| Notice of Allowability | Application No. | Applicant(s) | | |
| | 10/750,644 | BYTHEWOOD ET AL. | | |

EXAMINER'S AMENDMENT

FIG. 11

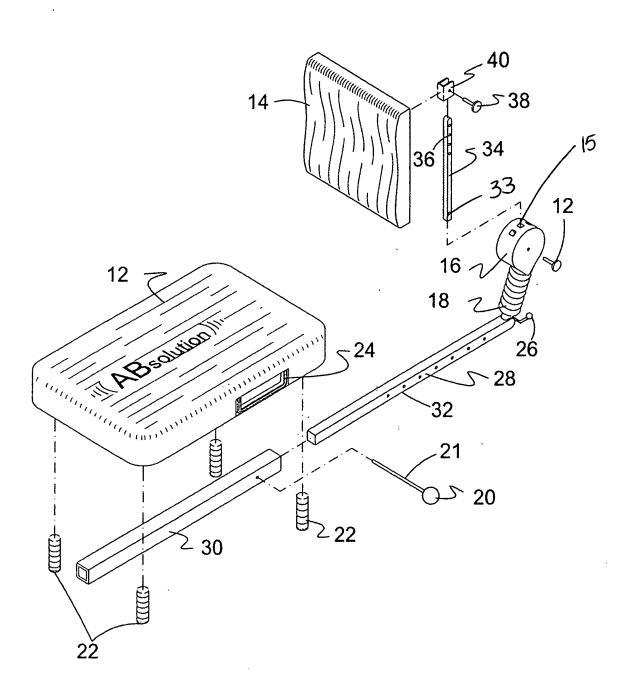
2. The following changes to the drawings have been approved by the examiner and agreed upon by applicant: Figure 11, reference numerals –15—and –33—have been inserted. In order to avoid abandonment of the application, applicant must make these above agreed upon drawing changes.
